**TCP/11/16(203)**

**Planning Application 12/00273/FLL – Erection of 2 wind turbines at Farmhouse, Mains of Murthly, Aberfeldy, PH15 2EA**

**PAPERS SUBMITTED  
BY THE  
APPLICANT**

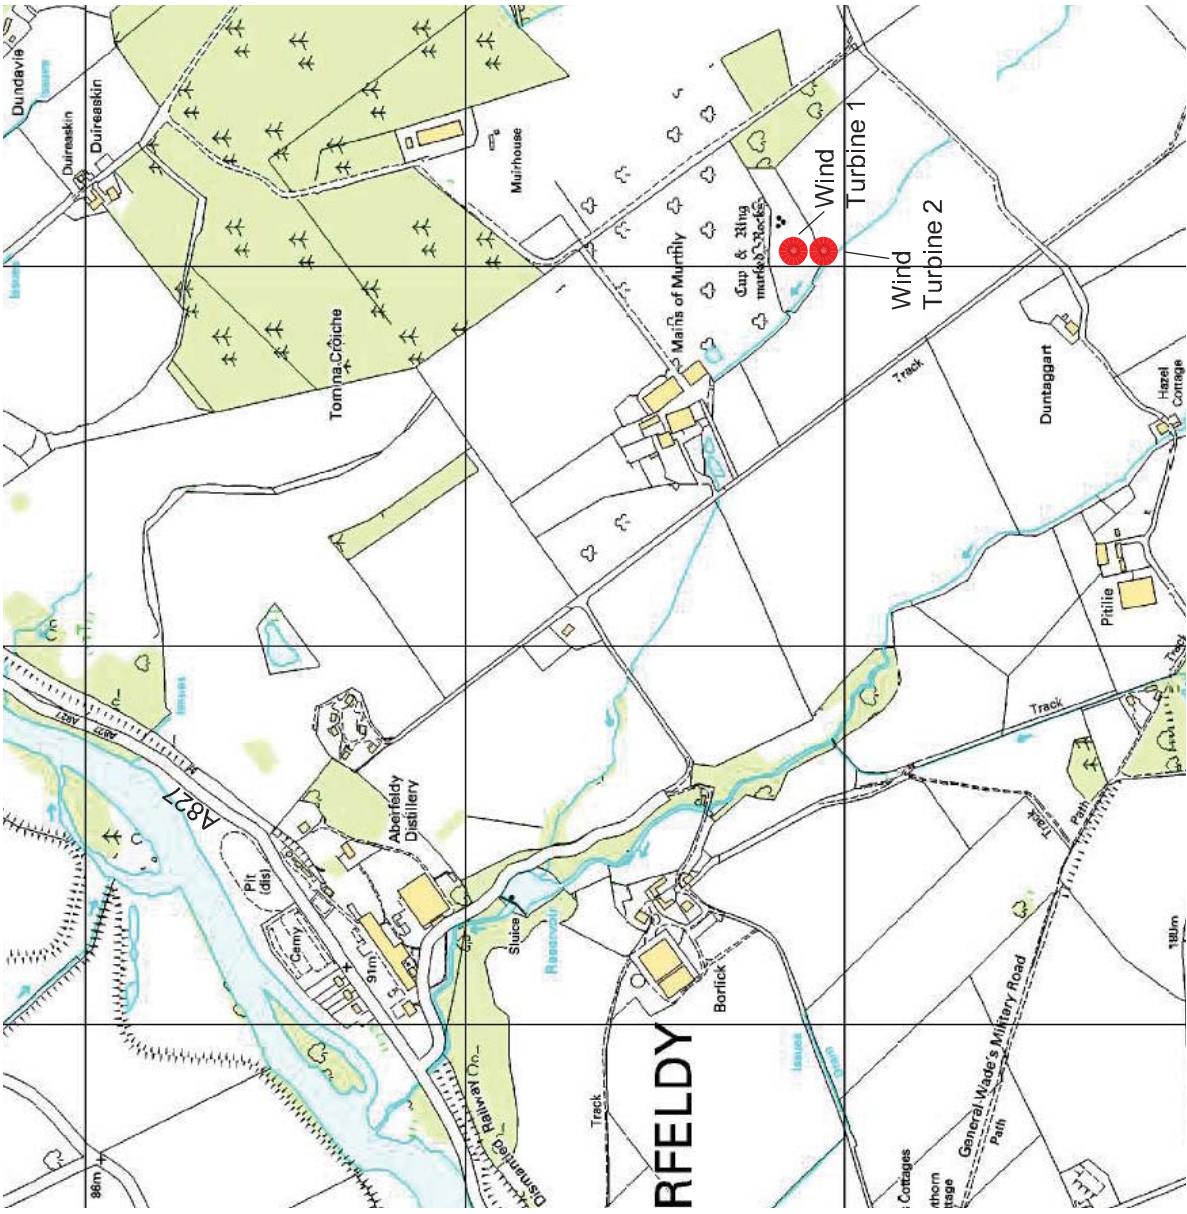
Aberfeldy Community Council	No response at time of report.
Perth And Kinross Area Archaeologist	Four cup marked stones (MPK965) are located in close proximity to the development area (please see map below). These cup marked stones include a boulder with 45 cup marks, including 1 ringed and one co-joining pair, a large fragmented piece of rock measuring with 7 small cup marks, 2 possible small cup marks and what is possibly a large badly weathered cup, a boulder with at least 25 cup marks including 4 ringed and 2 co-joining pairs, a rock high with one cup and ring mark and three possible cup marks. It is recommended that these archaeological features be preserved in situ and that temporary fencing is erected during the construction period to make the monument highly visible and to avoid accidental damage to the stones.
Scottish Water	No objections.

Following Scottish Planning Policy Historic Environment sections 110 and 124, it is recommended that an archaeological condition for fencing-off of archaeological sites should be attached to permission if given:

*No development shall take place until fencing has been erected, in a manner to be agreed with Perth and Kinross Heritage Trust and the Planning Authority, to protect site MPK965. Also, no works shall take beyond the fencing without the prior agreement of the Planning Authority and Perth and Kinross Heritage Trust.*

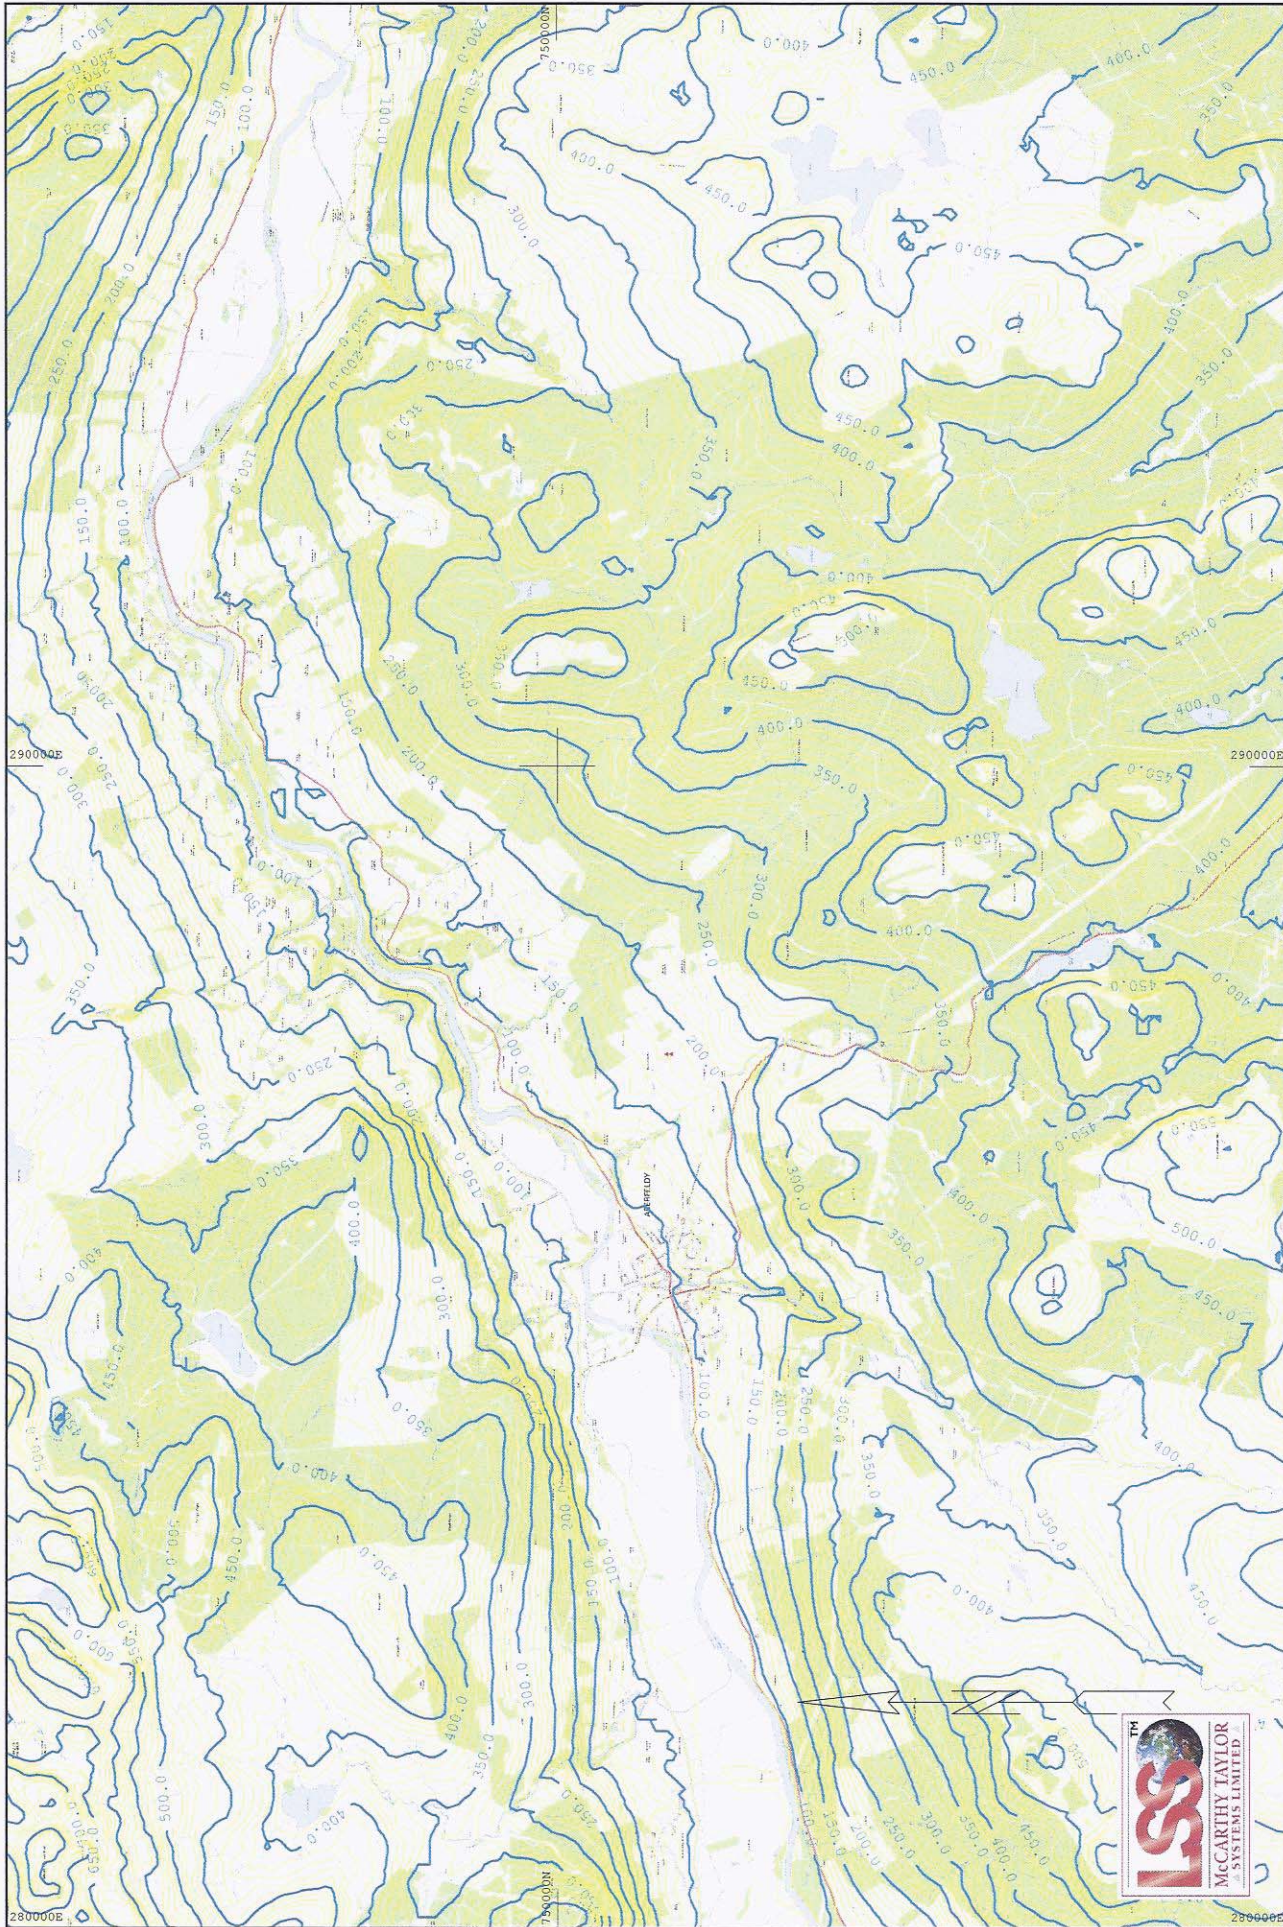
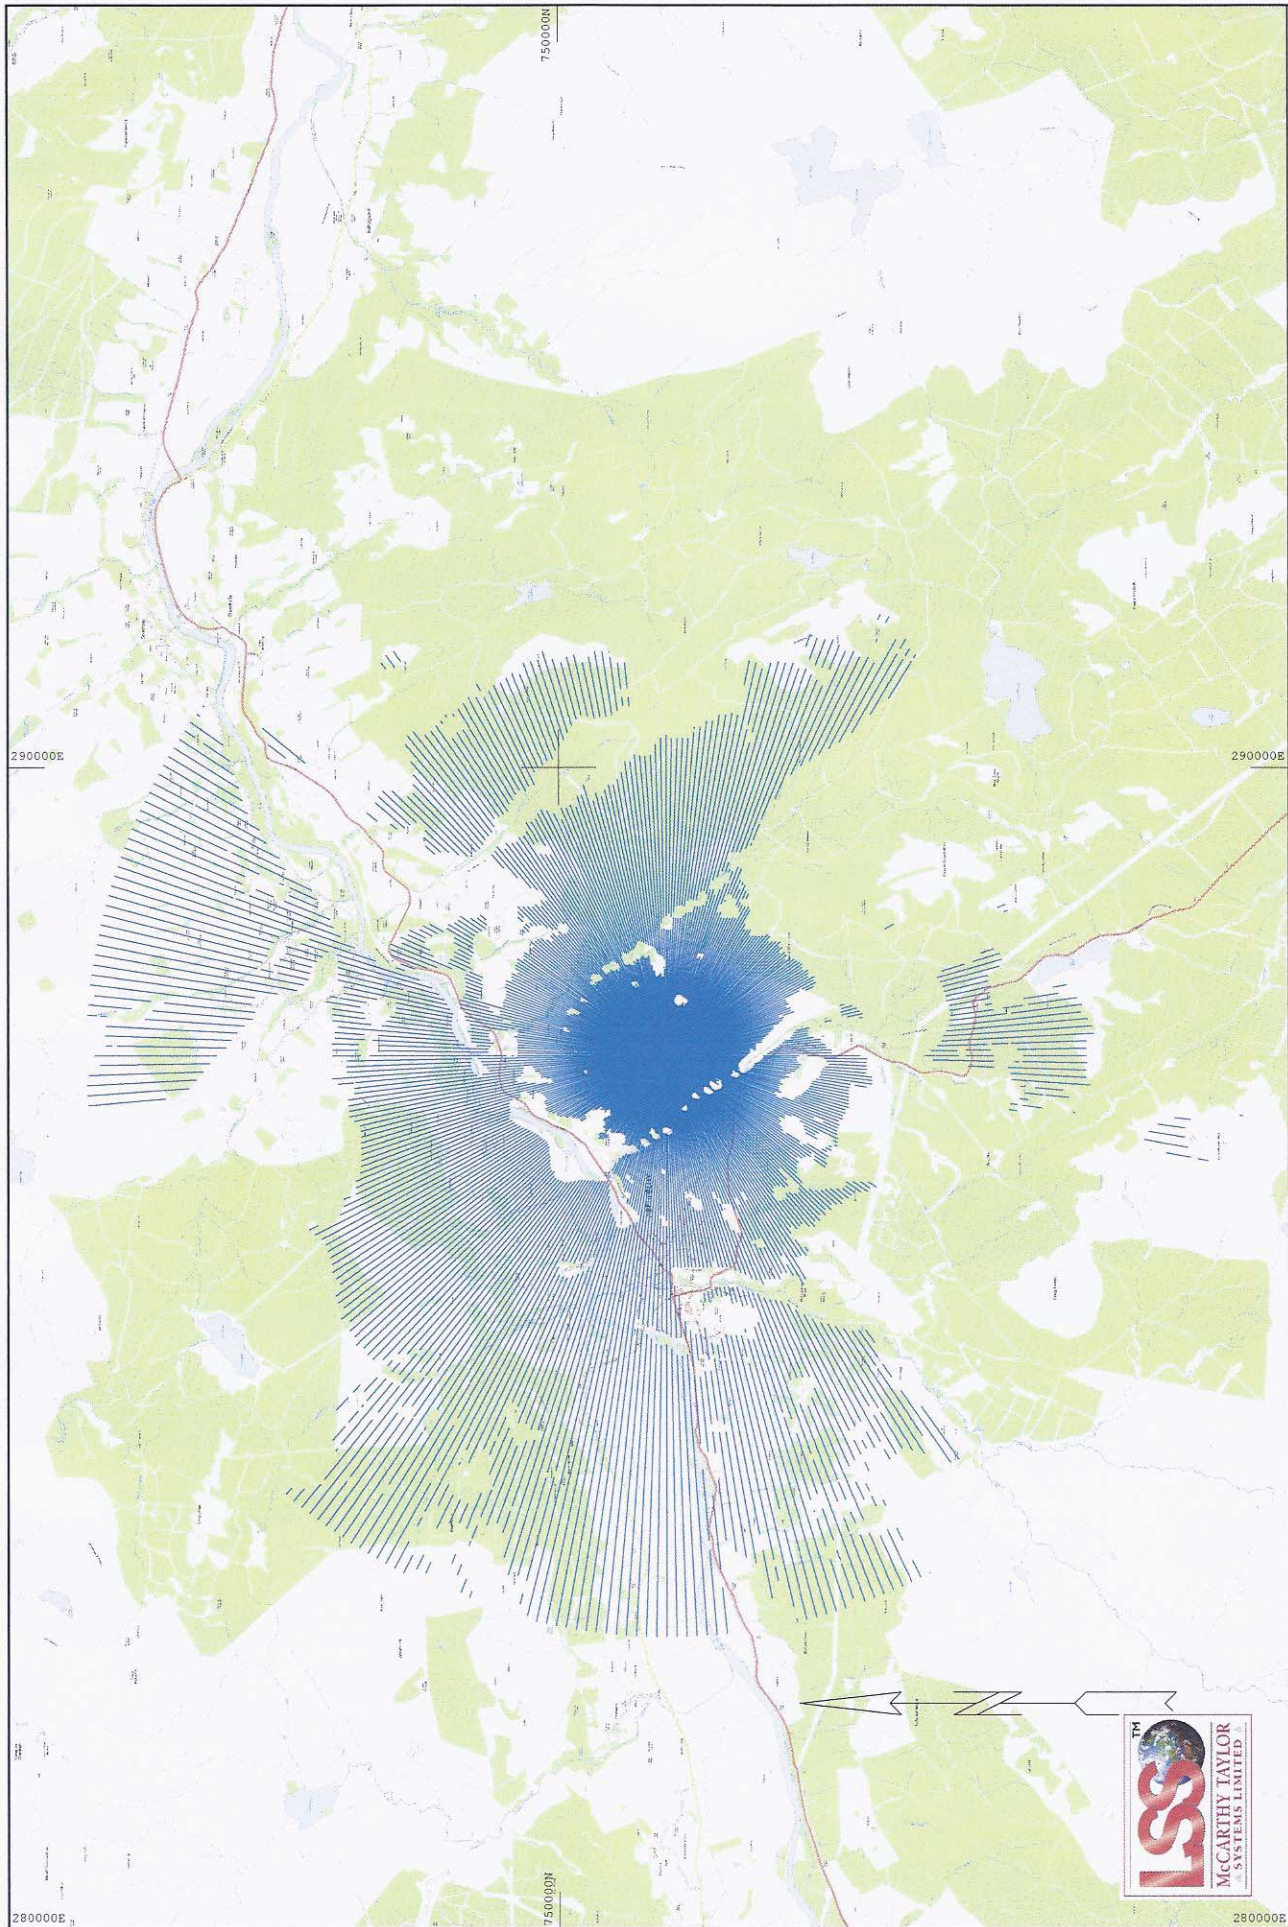
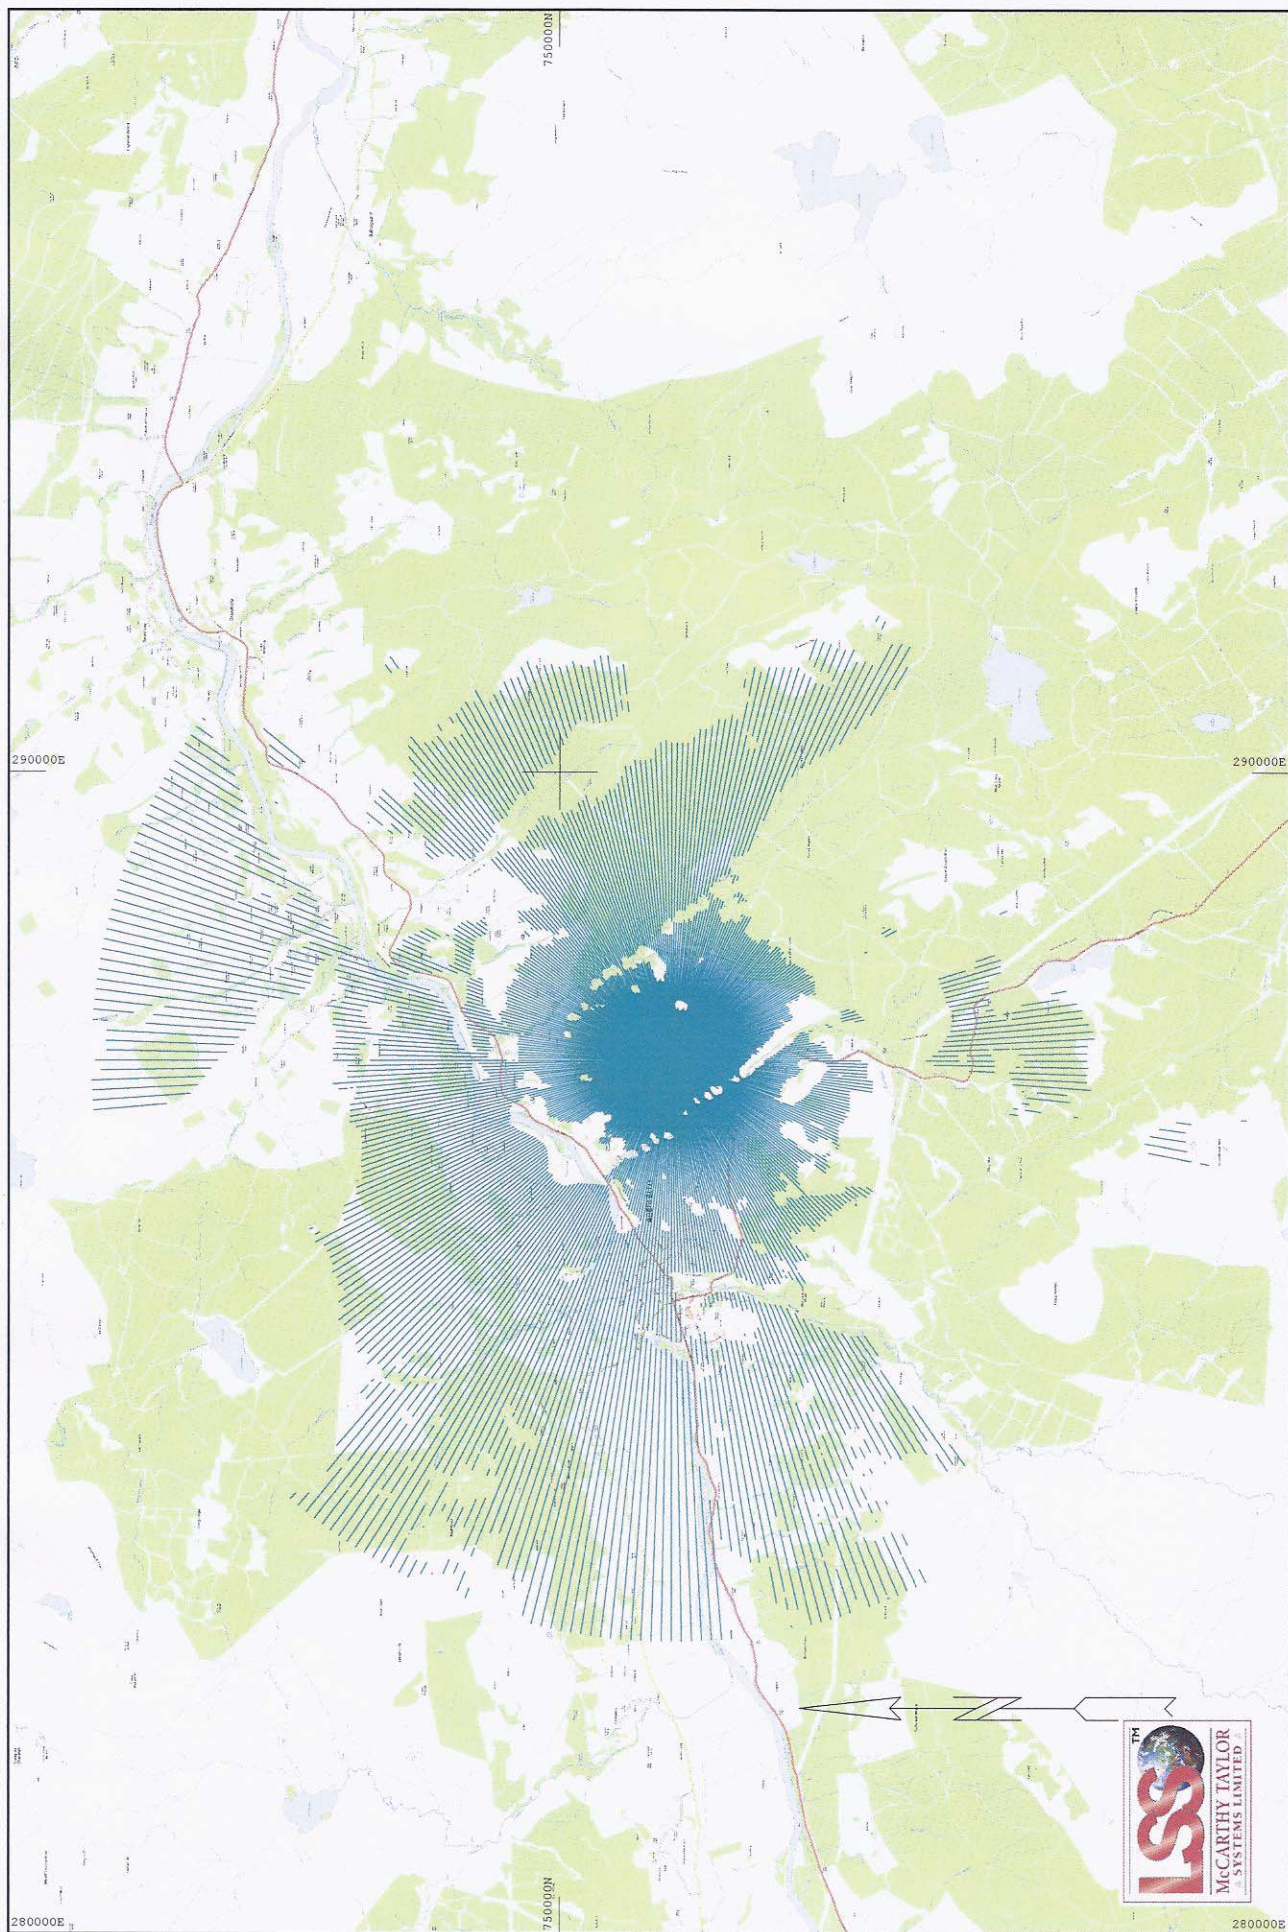
The submitted zones of turbines' visibility clearly show that both turbines will be readily visible from a very significant proportion of the surrounding countryside including from Castle Menzies Historic Garden/Designed Landscape, parts of Aberfeldy, the north side of the valley and the A827, a major tourist route. No photomontages have been submitted.

ZTV and site visit confirms that the two turbines at an overall tip height of 26.4 metres on rising land will be readily visible from parts of the A827 (which accommodates a lot of tourist traffic), parts of the Aberfeldy Conservation Area, residential areas and many rural locations. It is not clear from the supporting information whether the ZTV plans are based on hub height or tip height.
